# STUDER

## Service Information

Conversion Instructions to Software  
and Hardware up-date kit A820 MCH

SI 120a/88 2nd Edition E 10.85.6061

Fig. 4.1, Common Mode Adjustment

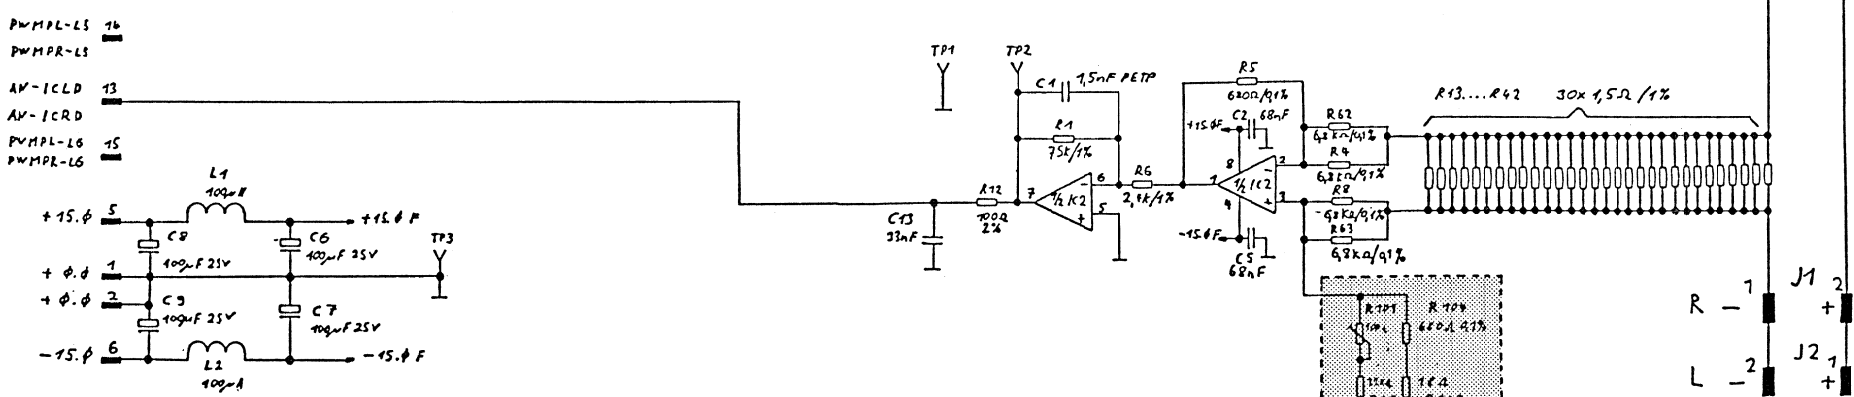
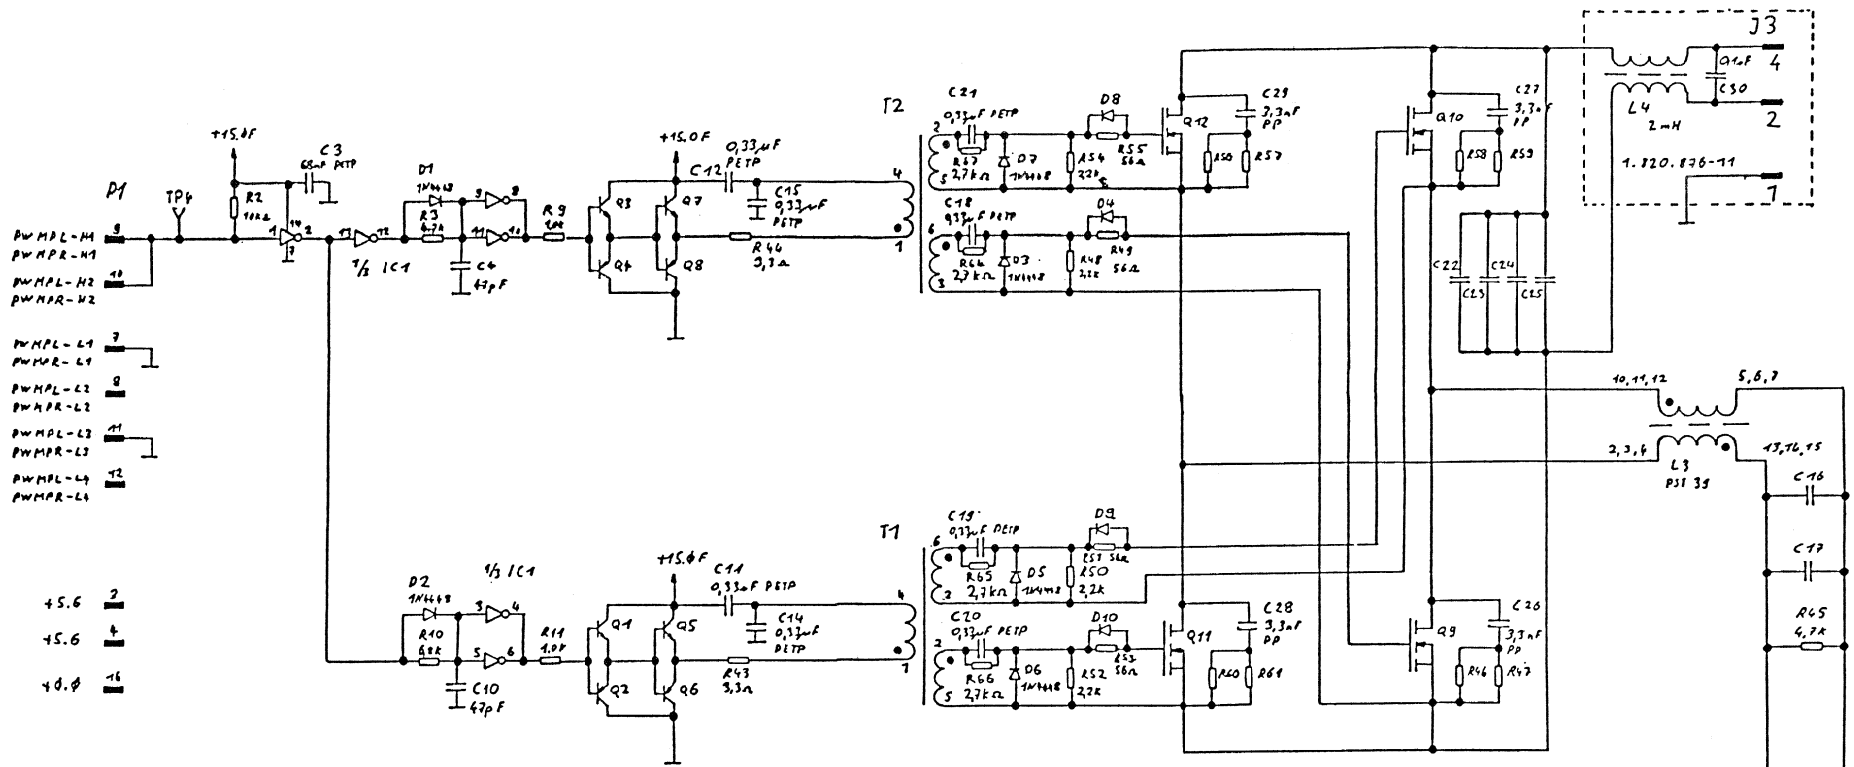
1. Remove resistor R7
2. Install Common Suppression Adjust Kit 1.820.878.00 :  
(see Schematics and Layout)
  - 2.1. Remove screw and mount the 12 mm - bolt.
  - 2.2. Solder the two pieces of wire into the holes on the additional print 1.820.878.00.
  - 2.3. Screw the additional print 1.820.878.00 onto the previously mounted bolt.
  - 2.4. Solder the two pieces of wire into the holes of R7.  
Check for good connection.
3. Attach label index .81 (1.010.081.43).

1. Connect only flat cable connector P1 to Spooling Motor Drive Amplifier. (All other connectors are unplugged.)
2. Switch tape recorder ON.
3. Measure offset voltage at TP2 (TP1 = ground) and write down offset voltage (voltage is between +/- 60 mV.)
4. Switch tape recorder OFF.
5. Apply a DC-voltage of +26 Volt to J1, Pin 1 with reference to TP1 (ground).  
Use for this purpose the +26 Volt on TP7 (TP3 = ground) of the Fuse/Supply Failure Detector 1.820.866.00.  
Make therefore the cable connections indicated in Fig.
6. Switch tape recorder ON.
7. Measure offset voltage at TP2 (TP1 = ground).  
Adjust with potentiometer R101 (10kohm) to the same offset voltage as measured under step 3 (tolerance +/- 10mV).
8. Switch tape recorder OFF.
9. Secure potentiometer with locking-paint.
10. Repeat steps 1 - 9 for the second Spooling Motor Drive Amplifier.

REMOVE SCREW  
&  
MOUNT THE  
BOLT

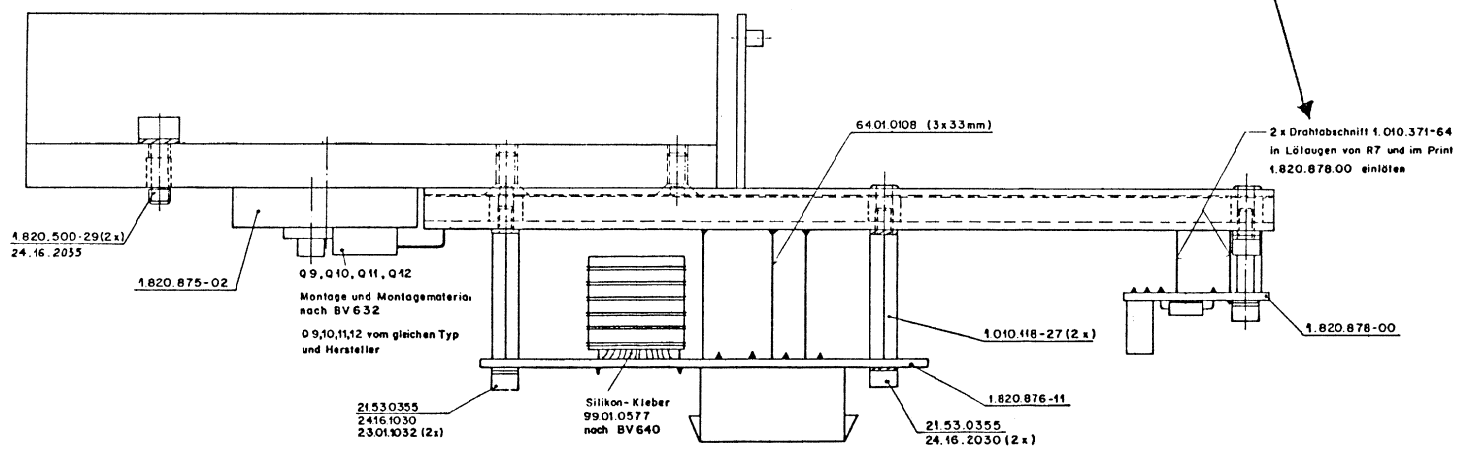
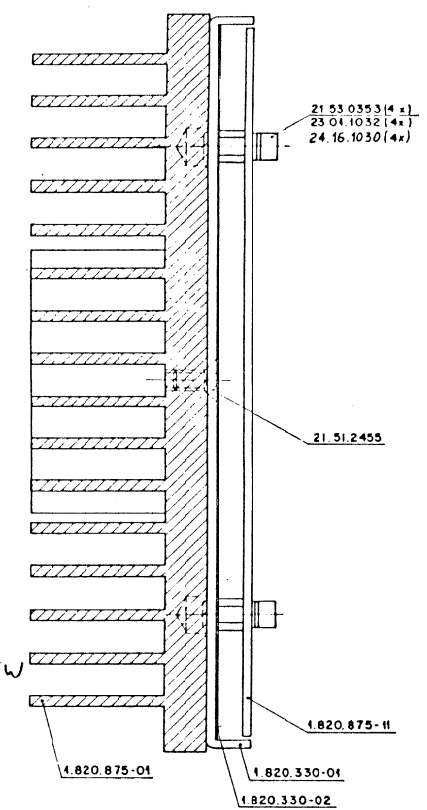
REMOVE R7  
R7 auslöten

2 x Drahtabschnitt 1.010.371-64  
in Lötösen von R7 und im Print  
1.820.878.00 einlöten

Fig. 4.2.

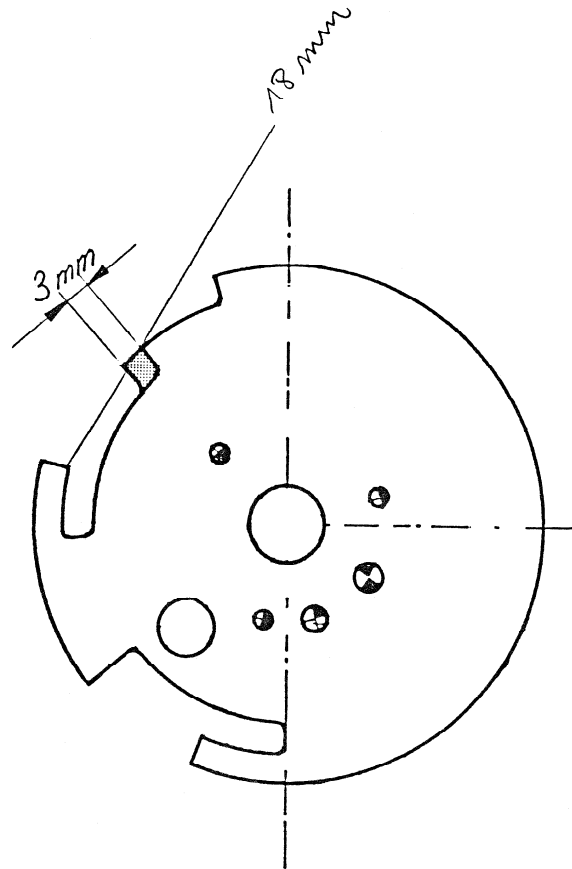
Insufficient stroke length of the pinch roller assembly may result in tape slippage.

The clearance of the pressure spring has to be increased to 0.5 ... 1mm.

1. Tilt up tape transport and remove right-hand Motor Assembly 1.820.141.00.
2. With a diagonal cutter or other suitable tool, shorten the right hand side control cam 1.820.141.06 by 3mm at the point indicated on the attached drawing. (Fig. X.X)
3. Motor assembly right 1.820.141.00 changes to 1.820.141.81. Attach index label .81 (1.010.081.43).

Fig. 4.3.

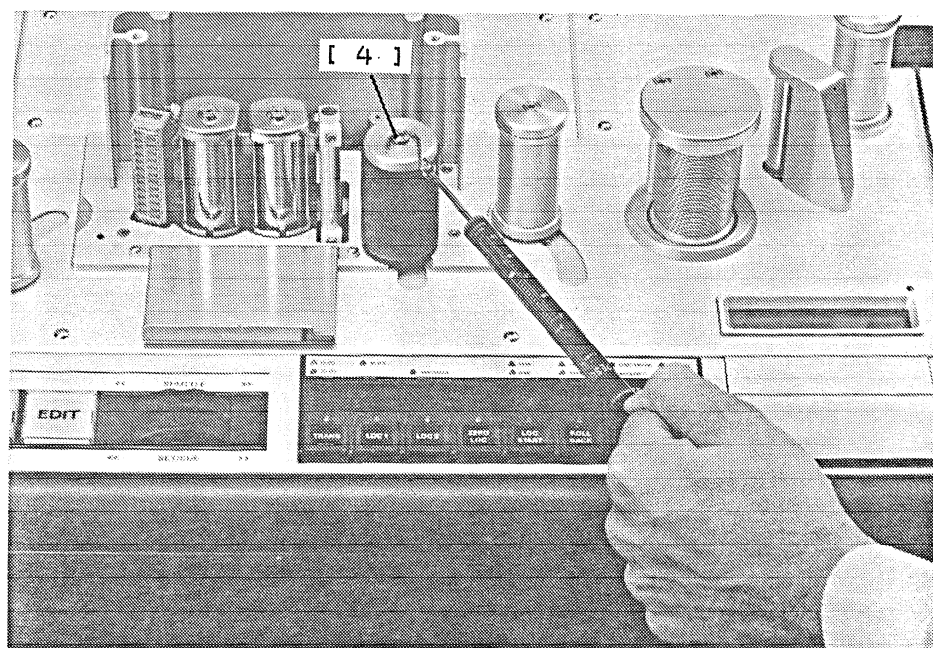
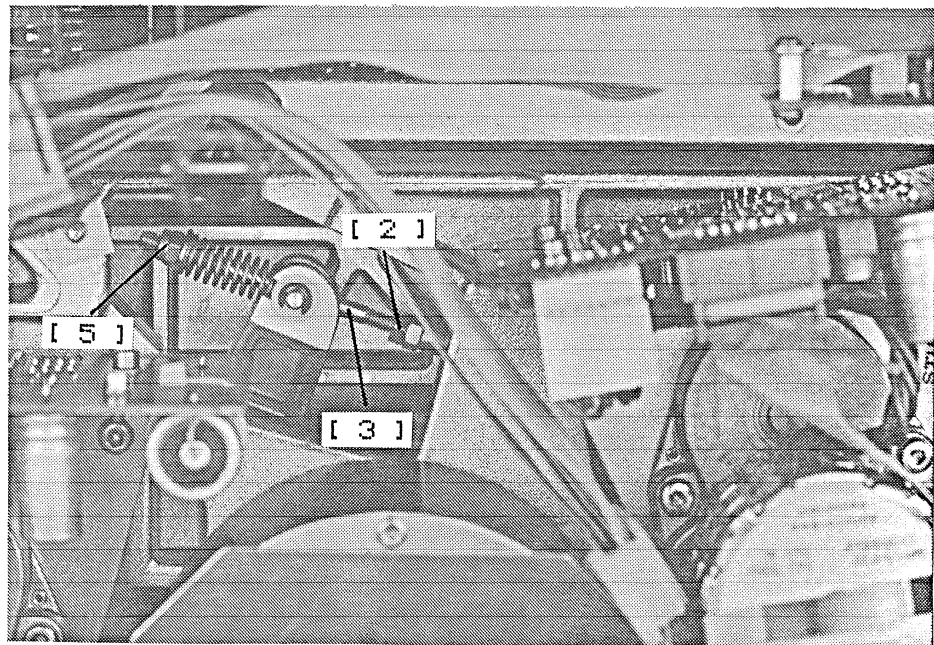
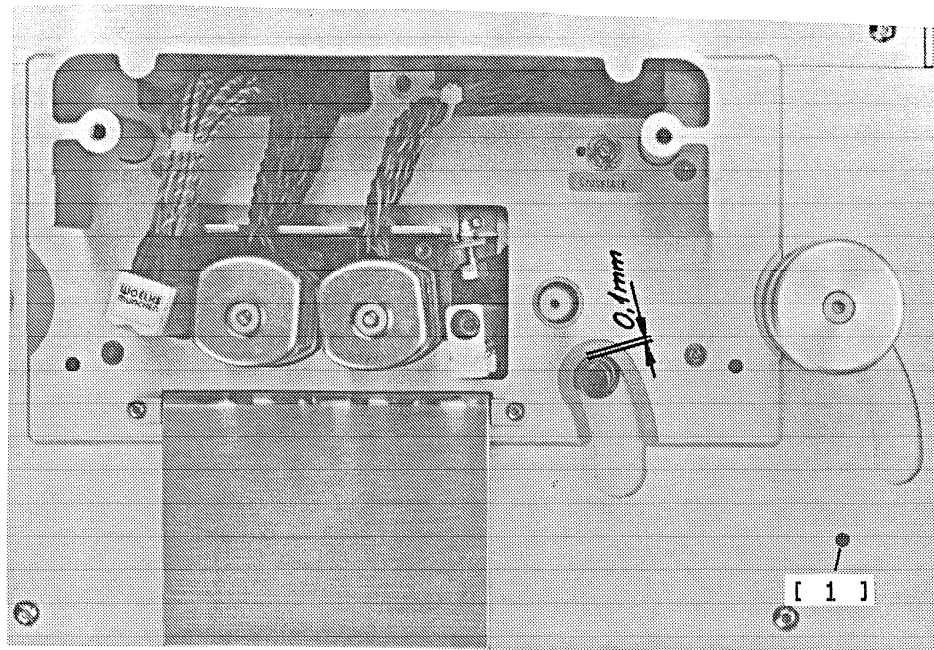
The modification necessitates a readjustment of the distance between the pinchroller shaft and the headblock plate.

1. Switch tape recorder OFF.
2. Remove pinch roller.
3. Insert allen key (3mm) into the hole [1] and turn the pinch roller assembly clockwise to the end stop (Play - Position).
4. Loosen locknut (opening between flats 7mm) [2] on the tie rod at the pinch unit and turn tie rod [3] until a distance of ca.0.1mm between pinchroller shaft and headblock plate is obtained.
5. Retighten locknut and secure with locking paint.
6. Install pinch roller.
